**Development Permit Panel**

**2. **Development Permit 12-615584****

**3. **Development Permit 13-630413****

4. **Development Permit 13-636863**  
(File Ref. No.: DP 13-636863) (REDMS No. 3980127)

Proposed 14 Unit  
Townhouse Project  
3100 Woodbridge Avenue  
Richmond, BC  
Tree Management Plan  
Date: 09/29/2012  
Project No: 12-615584  
Plan # 584

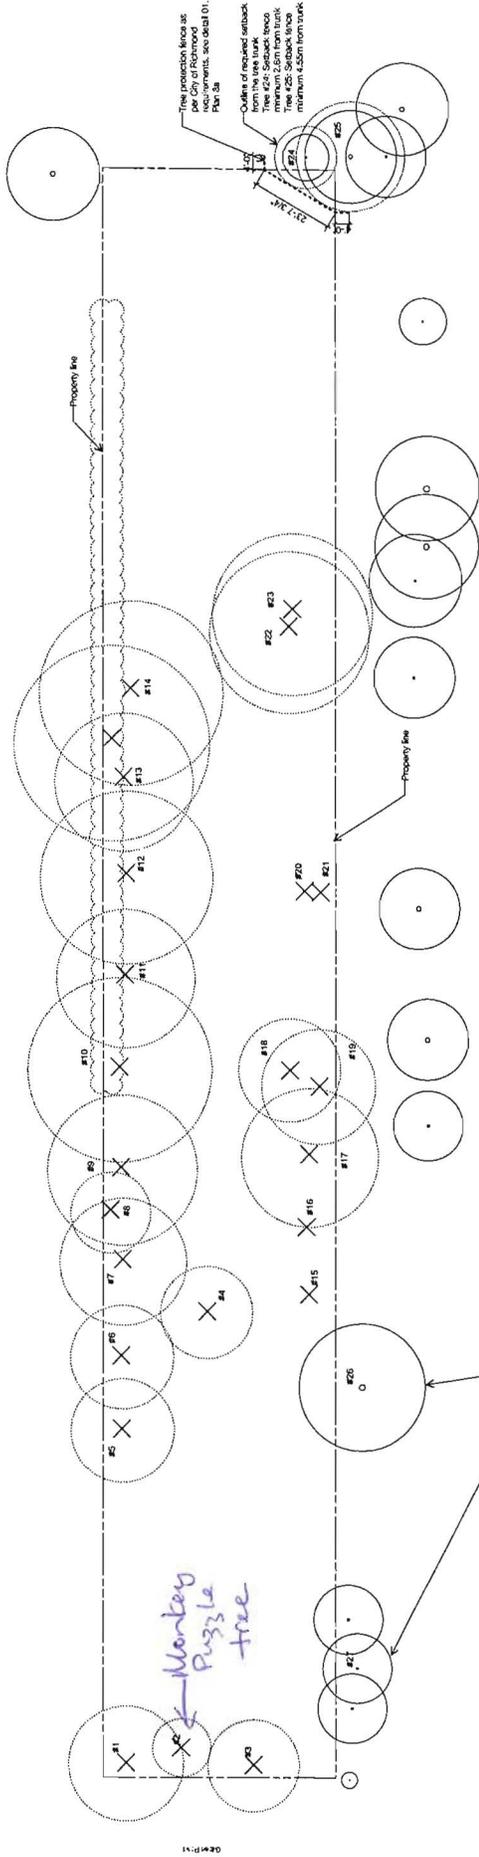
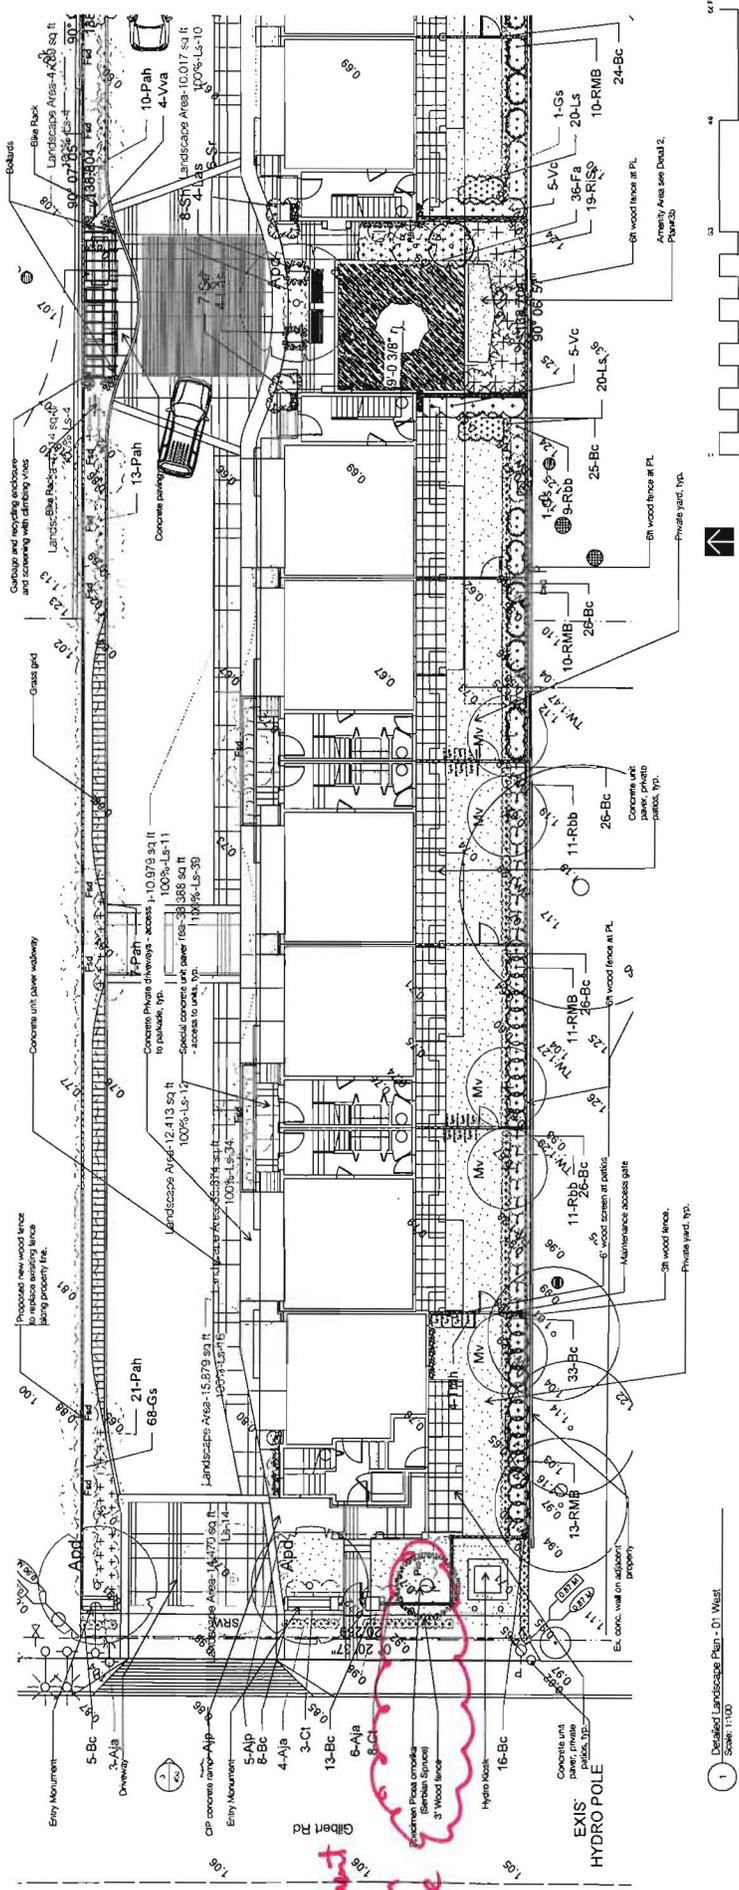
The applicant is proposing to replace the Monkey Puzzle tree with a 7.6 m (25 ft.) tall Serbian Spruce tree and install it in the location where the Monkey Puzzle tree was to be re-installed. The City's Tree Preservation Coordinator has reviewed the arborist's report and has no concern; he has also agreed that the upright narrow form of the Serbian Spruce tree makes it a suitable replacement tree for the relatively small front yard. No additional compensation is requested.

A qualified tree relocation specialist was retained by the developer to move and care for the Monkey Puzzle tree. The Monkey Puzzle tree was not able to be replanted on site as the trunk failed due to dry rot. The applicant is proposing to install the new Serbian Spruce tree at the same location where the Monkey Puzzle tree was to be installed; therefore, there is no substantive change to the landscape plans; only the species of the tree has been revised.

SCALE	DATE	DRAWN	CHECKED
3/32" = 1'-0"	JAN. 20, 2013	HP	
SHEET NO. <b>A1.0</b>			PROJ. NO. 1108

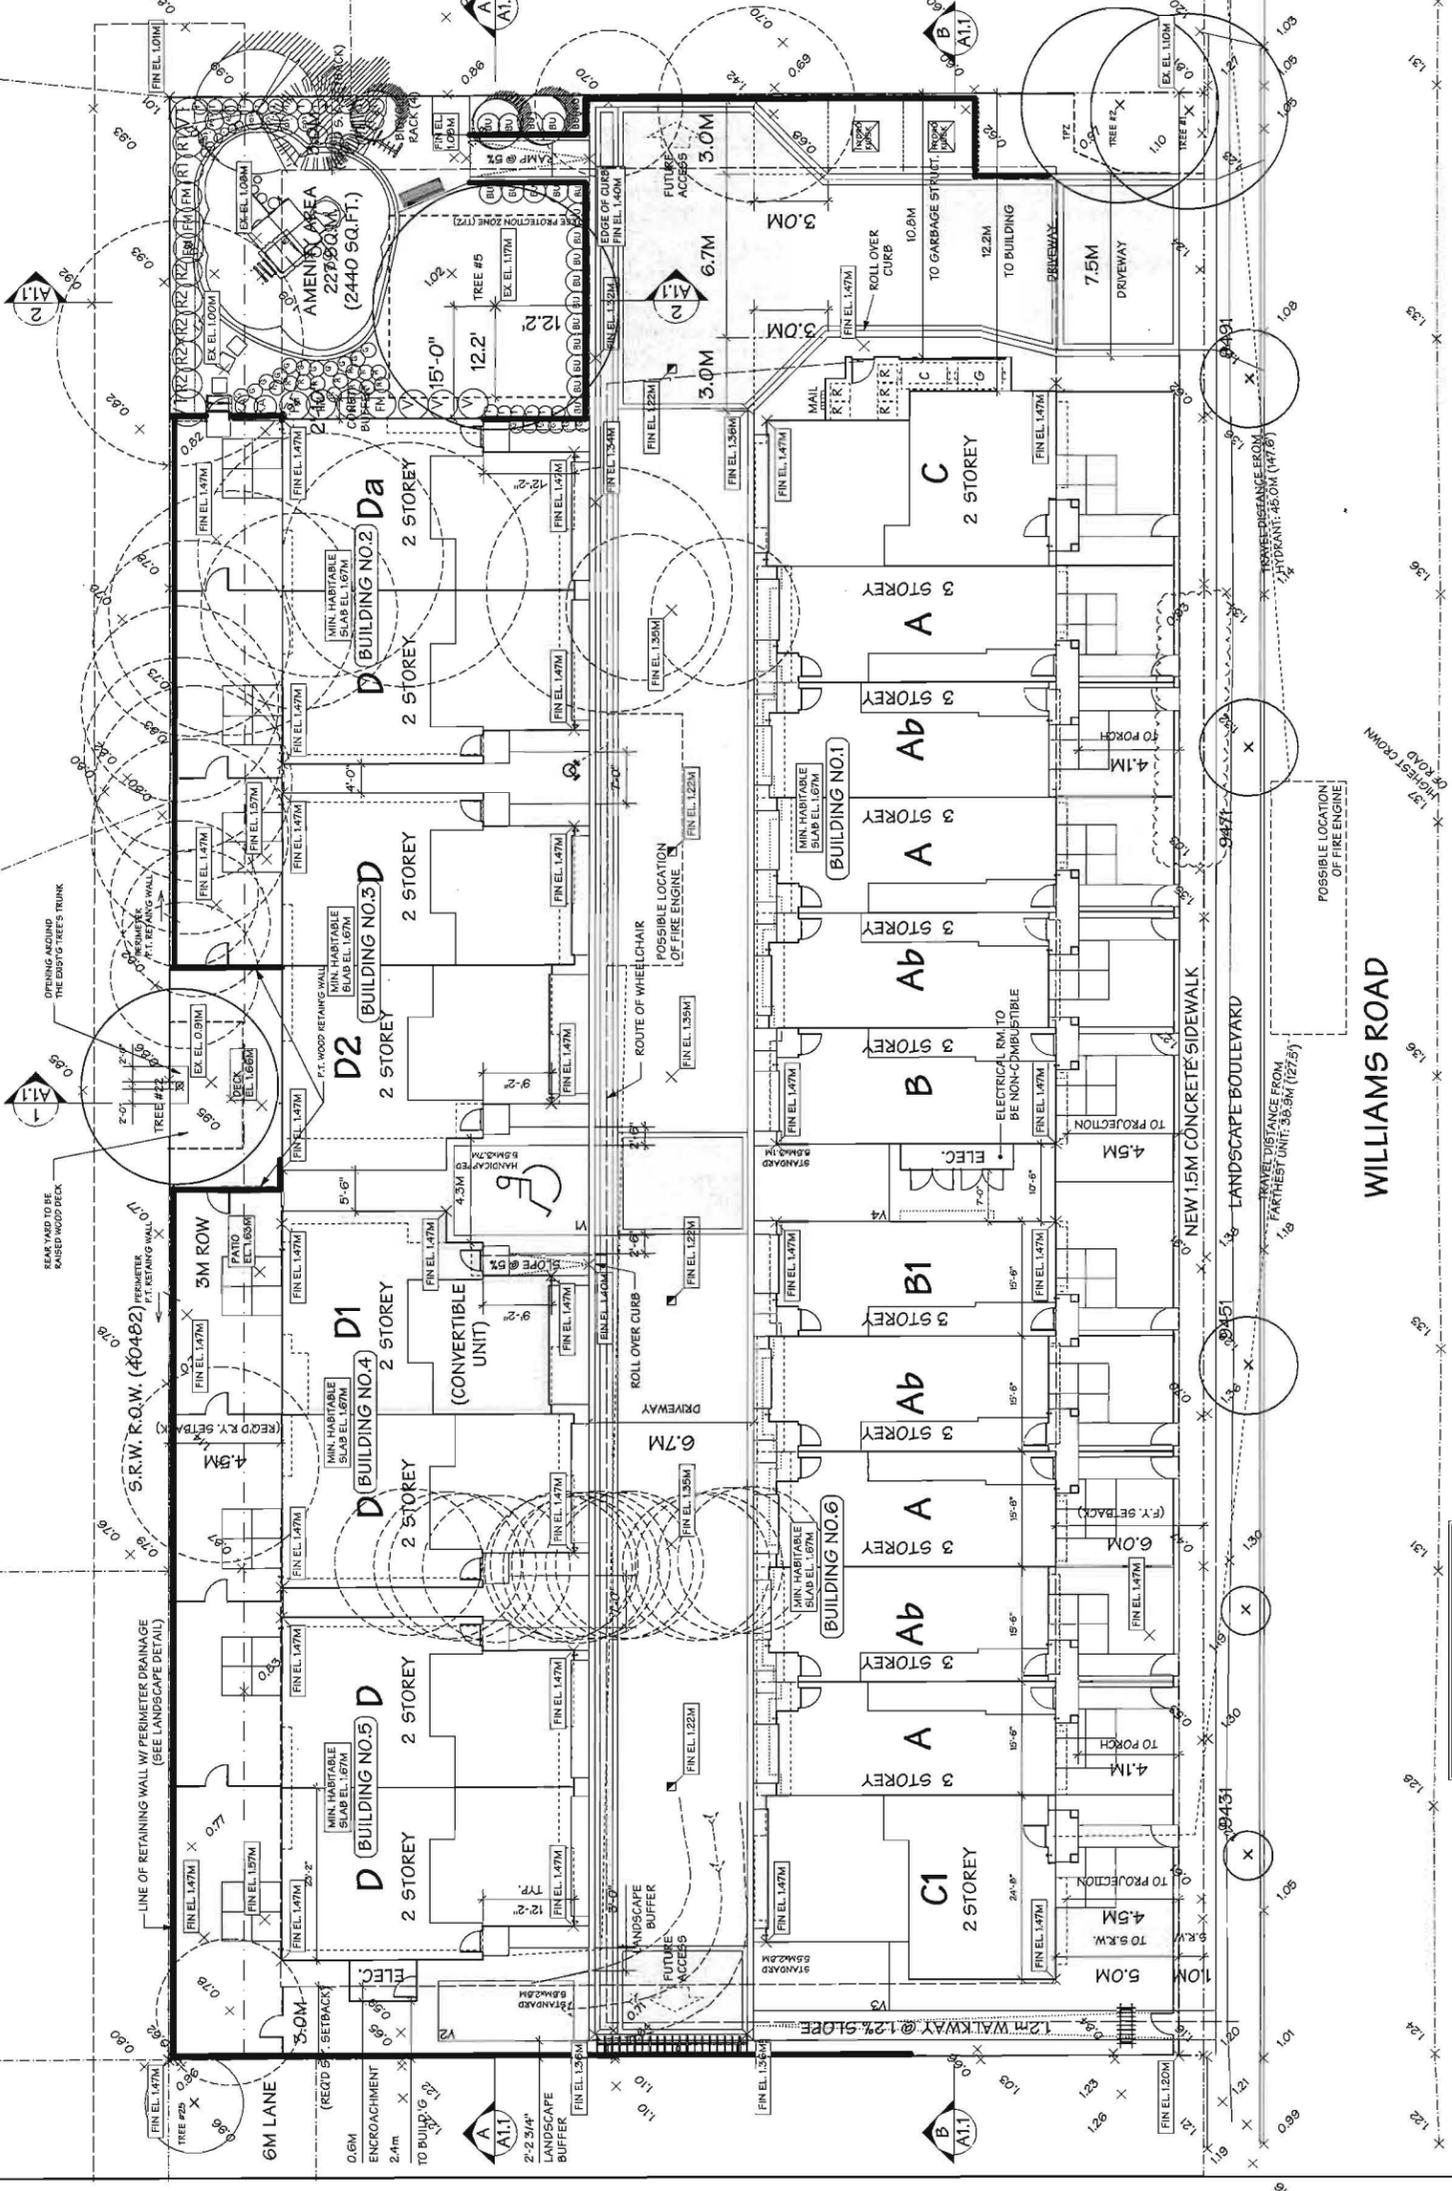
8. the subject development has put a lot of pressure on existing trees; follow the recommendations of the arborists;  
***As mentioned above, a 2.8' construction buffer provided between Tree Protection Area and building no. 2. A total of 15' is provided between the tree and building. TPZ shown at 12.2' from the tree as required. See sheet A1.0.***

DRAWING TITLE:  
**LANDSCAPE PLAN**

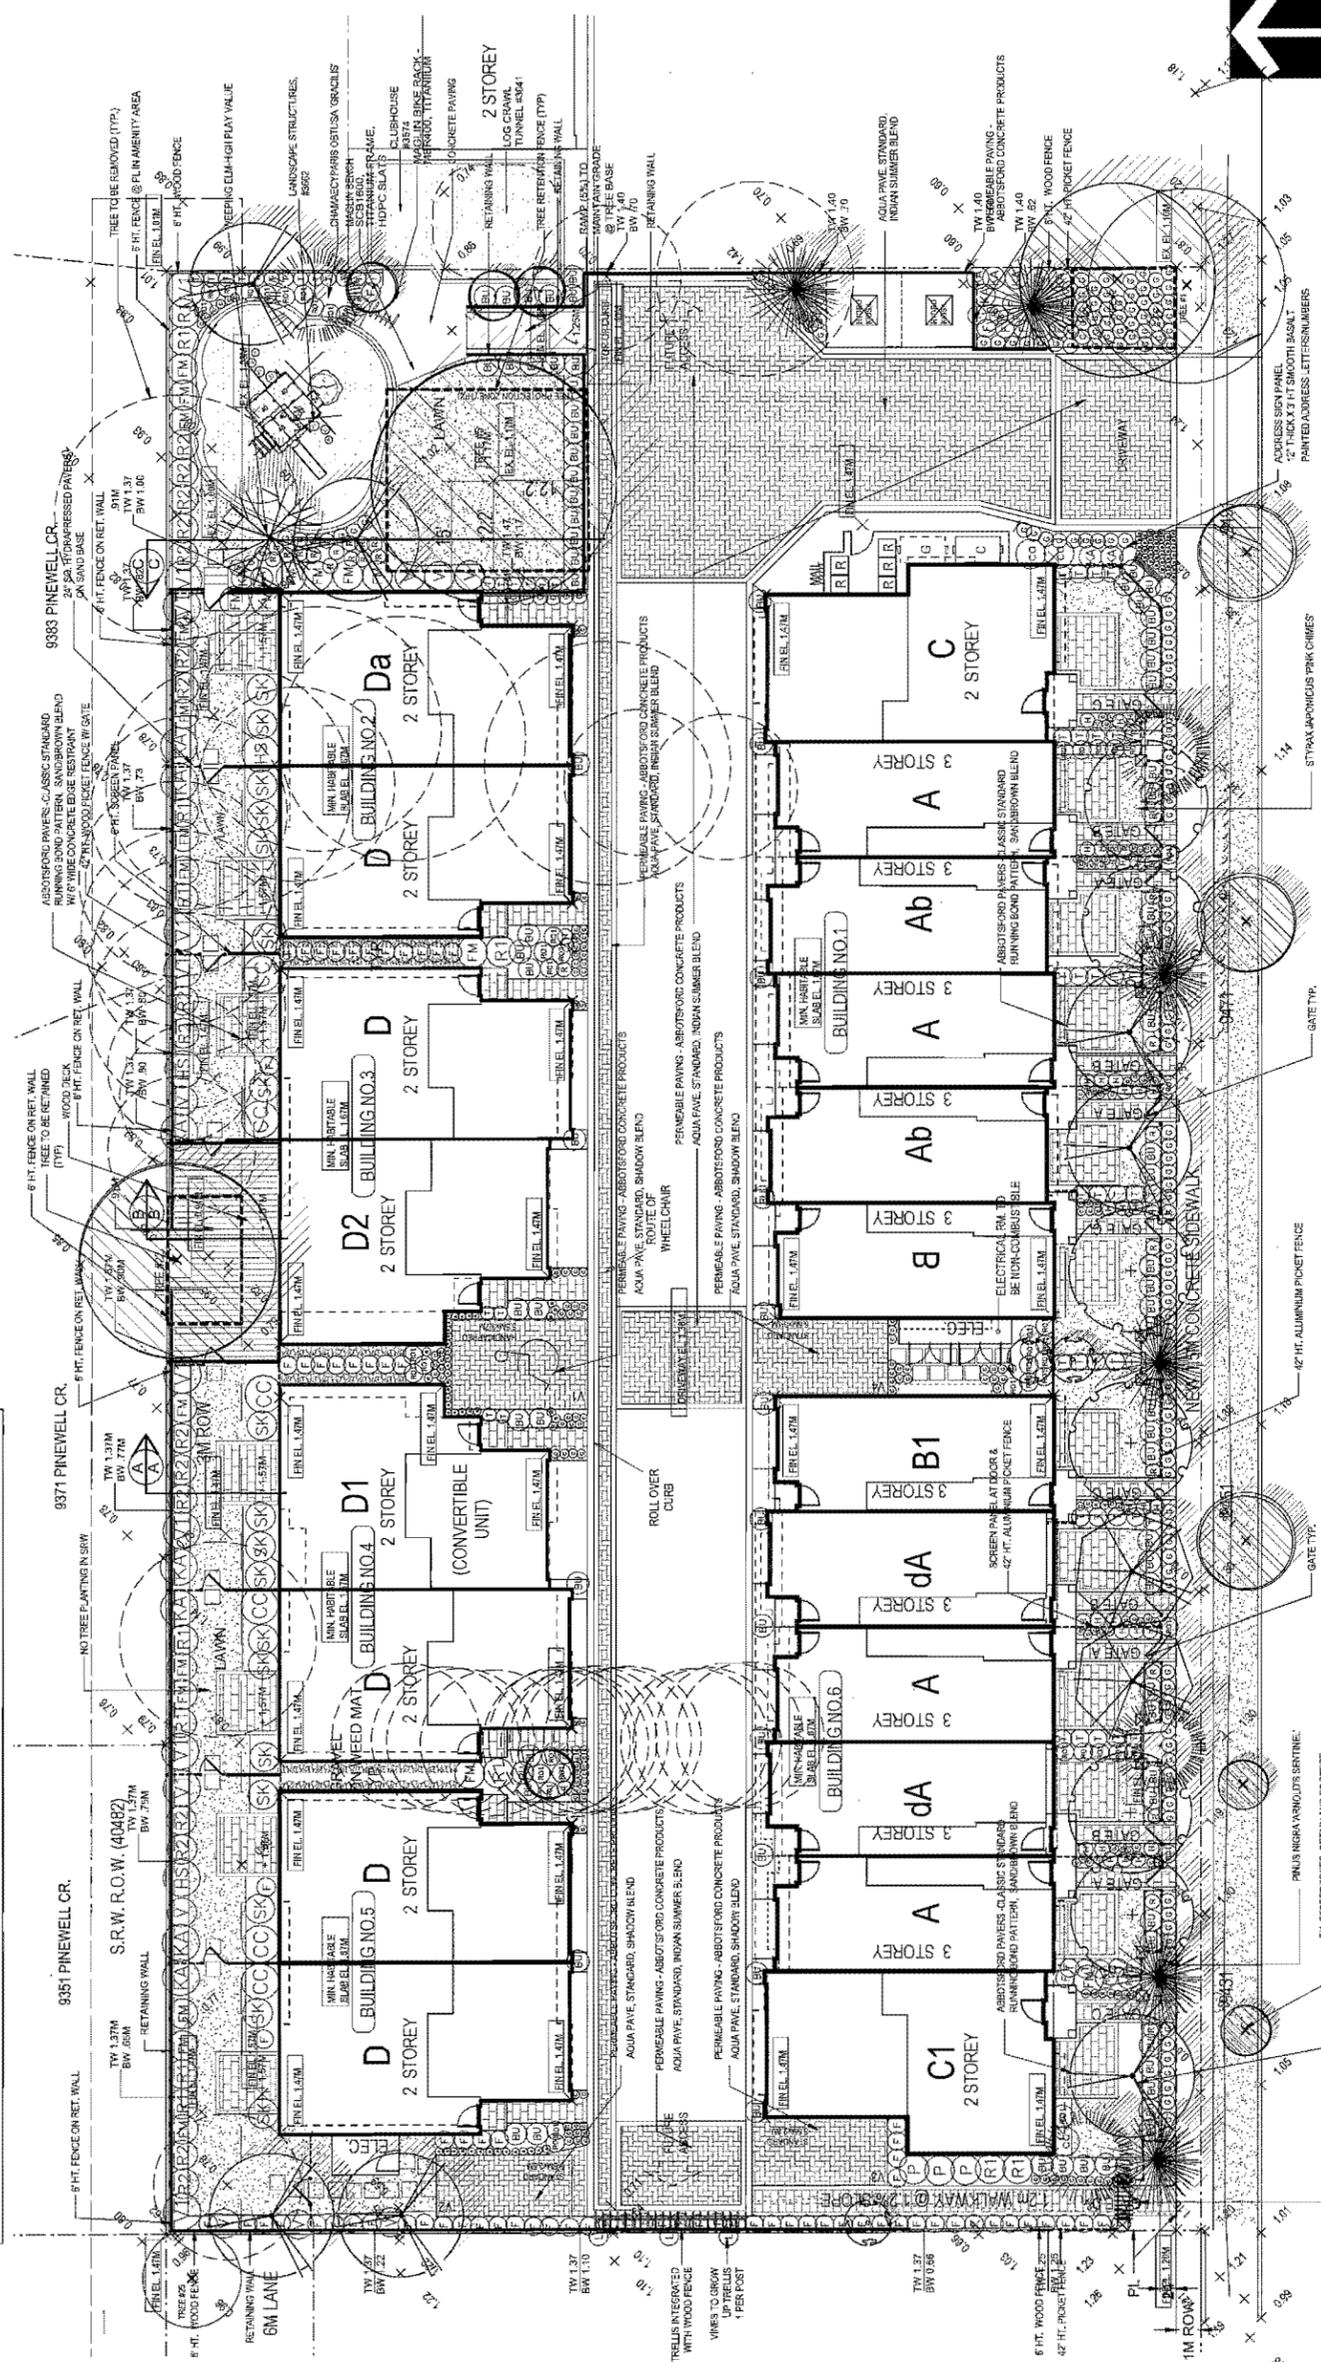
4. increase the lighting in the outdoor amenity space; limit the height of trees in the area up to 6 feet to enhance surveillance; ensure people entering the development can clearly see into the common outdoor amenity area;  
*Low planting along the base of the retaining wall provided to enhance surveillance in the outdoor amenity area. See sheet 3A and 3C.*

9. concern on the survivability of proposed plant species to be planted in the narrow slots between the buildings; consider means to ensure survival;

***Gravel to be proposed at narrow slots between buildings. See sheet 3A.***
10. massing is successful; appreciate the stepping down of end units to blend well with adjacent single family developments;
